**PLANNED UNIT DEVELOPMENT  
& SUBDIVISION STAFF REPORT****Date: April 5, 2012****DEVELOPMENT NAME** Pinehurst Subdivision, Re-subdivision of Lot 3, Block 116**SUBDIVISION NAME** Pinehurst Subdivision, Re-subdivision of Lot 3, Block 116**LOCATION** Southern terminus of Schaub Avenue**CITY COUNCIL  
DISTRICT** District 6**PRESENT ZONING** R-1, Single-Family Residential District**AREA OF PROPERTY** Subdivision 2 Lots / 0.2 ± acres  
Planned Unit Development 2 Lots / 0.2 ± acres**CONTEMPLATED USE** Planned Unit Development approval to allow reduced lot sizes and reduced lot widths in a proposed subdivision.**TIME SCHEDULE  
FOR DEVELOPMENT** Immediately**ENGINEERING  
COMMENTS**

# SITE PLAN

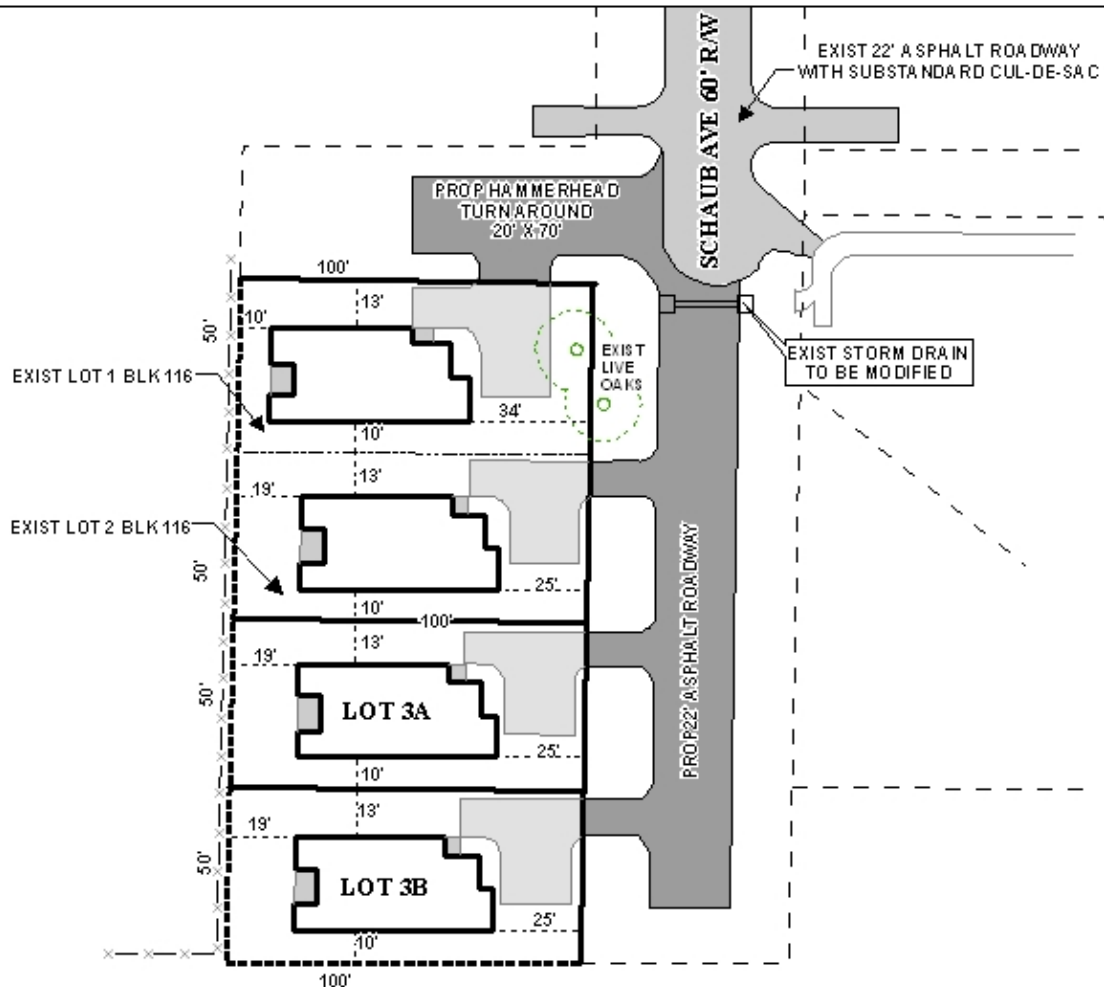
Driveway number, size, location and design to be approved by Traffic Engineering and conform to AASHTO standards. The driveway to Lot 1 from the proposed hammerhead should be 10' to match the proposed driveways for the other three lots.

Tree removal permits are required from Urban Forestry before removing or trimming 24" DBH or larger Live Oak Trees from proposed Lot 1.

Tree removal permits are required from the Mobile Tree Commission before removing any trees within the right of way. This includes the unopened right of way North of proposed Lot 1.

The turnaround (preferably the 96 foot diameter cul-de-sac) is to be located at the end of the roadway or within 150 feet of the end of the roadway to limit the backing distance of an emergency vehicle to a maximum of 150 feet.

As previously stated, the site fronts Schaub Avenue to the East, and Lot 1 fronts McMurray Street to the North and Schaub Avenue to the East. Schaub Avenue is a closed-end street depicted with an adequate right-of-way of 60 feet. The Schaub Avenue right-of-way extends 200 feet south of McMurray Street to its terminus. Section V.B.6. requires a turnaround be provided for closed-end streets. Sections V.B.14. and V.B.15. of the Subdivision Regulations require a circular cul-de-sac with a right-of-way diameter of 120 feet and a roadway width of 96 feet.

The applicant wishes to construct Schaub Avenue to city standards to the terminus and provide a turnaround consistent with a modified 120-foot hammerhead as outlined in the 2009 International Fire Code, which has been adopted by the City of Mobile. The applicant proposes to construct the turnaround at the intersection of Schaub Avenue and McMurray Street, utilizing existing right-of-way. While this could ordinarily be considered an acceptable alternative to Sections V.B.14. and V.B.15., the Fire Code also states that the turnaround must be within 150 feet of the end of the roadway to limit the backing distance of an emergency vehicle to a maximum of 150 feet. In this case, the end of the roadway is 200 feet from the turnaround, and thus not compliance with the Fire Code. The Mobile Fire-Rescue Department has made this same point in their comments for this case.

Because of non-compliance with the Fire Code, a waiver for the turnaround would be inappropriate. As such, the PUD and Subdivision applications should be denied.

**Subdivision:** The plat does not meet the minimum requirements of the Subdivision Regulations and is recommended for denial for the following reasons:

- 1) non-compliance with Sections V.B.14. and V.B.15. of the Subdivision Regulations regarding right-of-way widths and roadway widths; and
- 2) non-compliance with the International Fire Code.

**Planned Unit Development:** Based upon the preceding, this application is recommended for denial for the following reasons:

- 1) the subdivision does not comply with Sections V.B.14. and V.B.15. of the Subdivision Regulations regarding right-of-way widths and roadway widths; and
- 2) the subdivision does not comply with the International Fire Code.
